SUBJECT: **Safety Recall 16S41 – Supplement #3**
Certain 2010-2012 Model Year Escape and 2010-2011 Model Year Mariner Vehicles
with a 3.0L Engine
Fuel Delivery Module Flange Replacement

REF : Safety Recall 16S41 – Supplement #2
Dated: January 11, 2018

New! REASON FOR THIS SUPPLEMENT

FIGURE 8

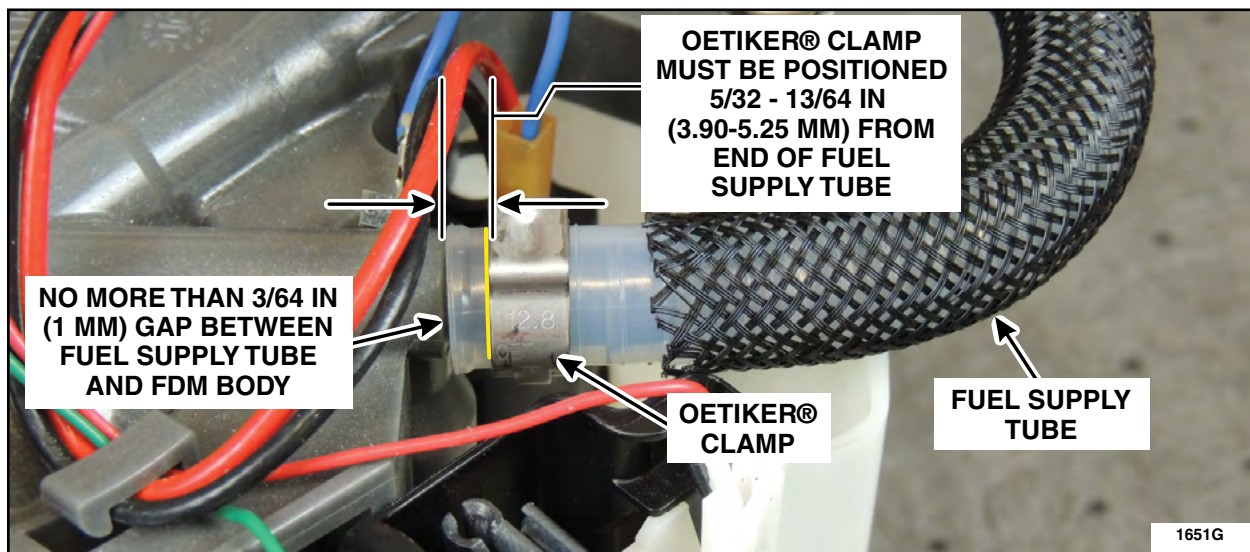
8. Connect the new fuel supply tube to the supply port and mark the installation position of the Oetiker® clamp prior to tightening. Improper location can cause a fuel pressure bleed down. See Figure 8.

FIGURE 9

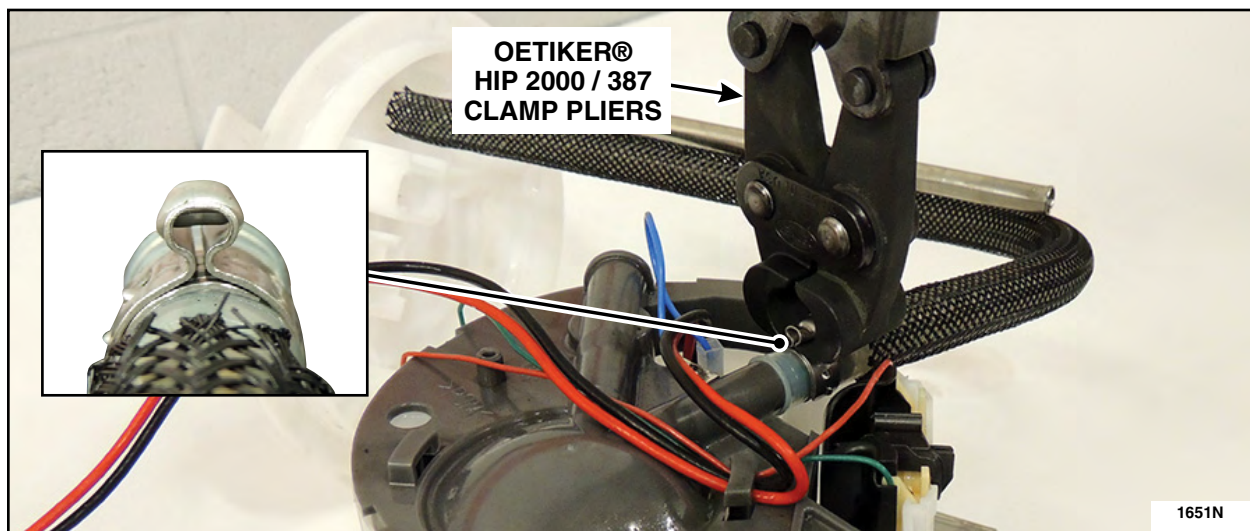
9. Tighten the Oetiker® clamp using Oetiker® HIP 2000 / 387 (or equivalent) clamp pliers.
See Figures 9 and 10.

NOTE: Only Oetiker® clamp pliers (or equivalent) should be used to clamp the Oetiker® clamp. If any other type of pliers are used such as side cutters or CV axle clamp pliers, a long crank or hard start condition will likely occur due to fuel pressure bleed down.

NOTE: Do not replace the fuel delivery module or fuel delivery module flange kit for long crank or hard start symptoms that result after performing this repair. In the event an Oetiker® clamp is damaged or improperly clamped during installation, the Oetiker® clamp is available to order separate from the Fuel Delivery Module Flange Kit. Refer to the dealer bulletin for parts ordering information.

FIGURE 11

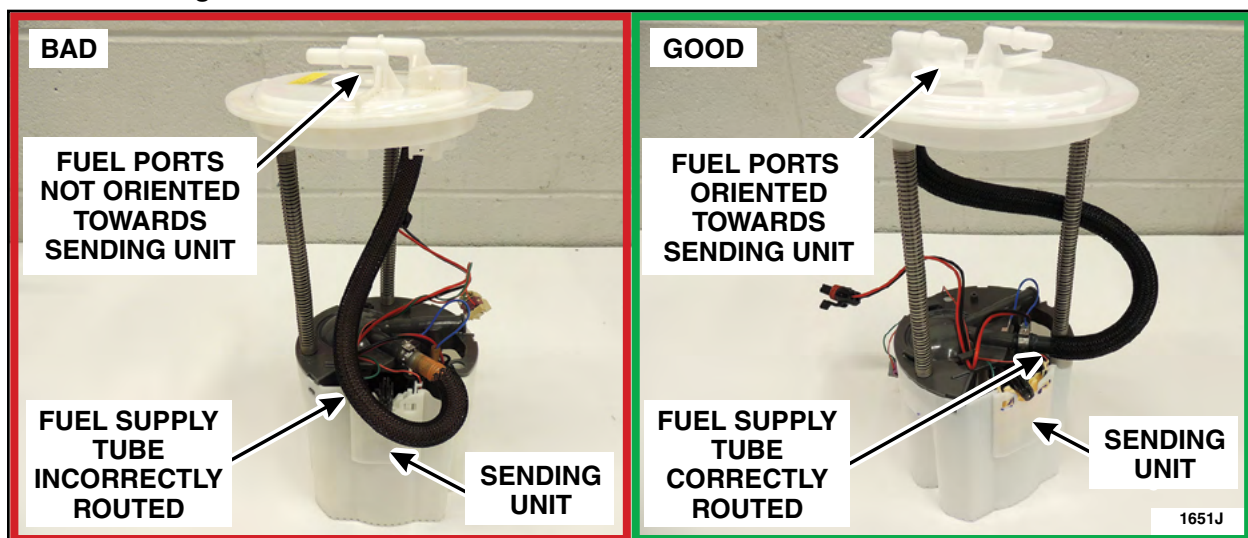
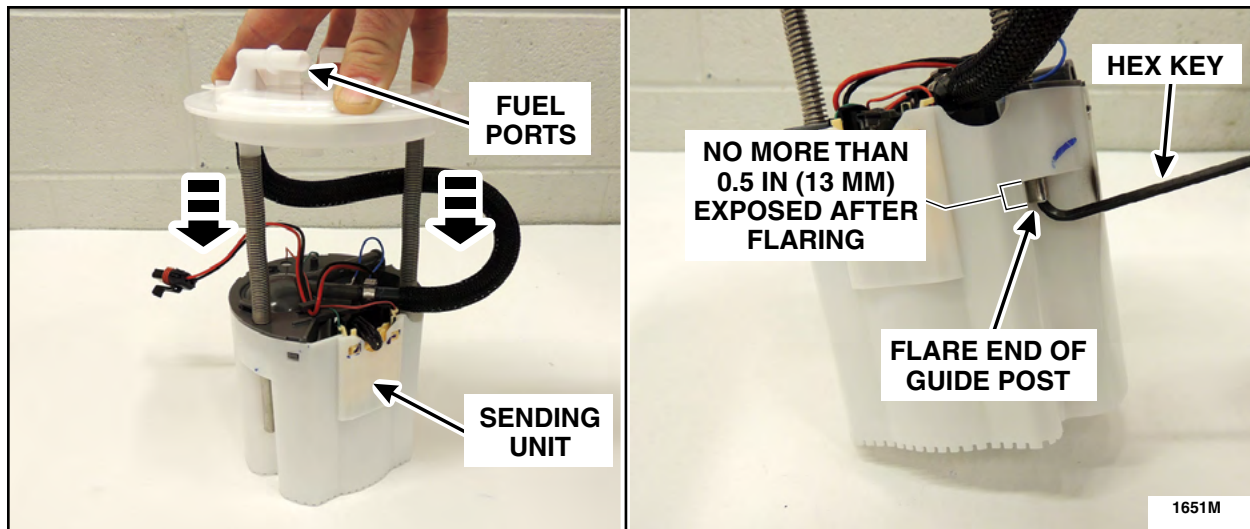
10. Install the *new* FDM flange, paying close attention to the proper orientation of the FDM flange to FDM.
See Figures 11 and 12.

- Using a suitable tool, such as a hex key, flare the end of each guide post to secure the flange to the lower module.
- *After both guide posts have been flared, gently pull on the FDM flange to ensure it is properly secured to the FDM.*

NOTE: When installing the *new* FDM flange, the flange must be aligned properly so the ports are pointing towards the sending unit side of the FDM.

NOTICE: When flaring the end of each guide post, only apply enough pressure to prevent the guide post from pulling through the lower module. Using excessive pressure when flaring may cause bending of the guide post, which can limit the necessary travel of the flange. The flared guide post should look similar to Figure 5, and no more than 1/2 in (12.7 mm) of the guide post should be exposed on the bottom side of the FDM after flaring.
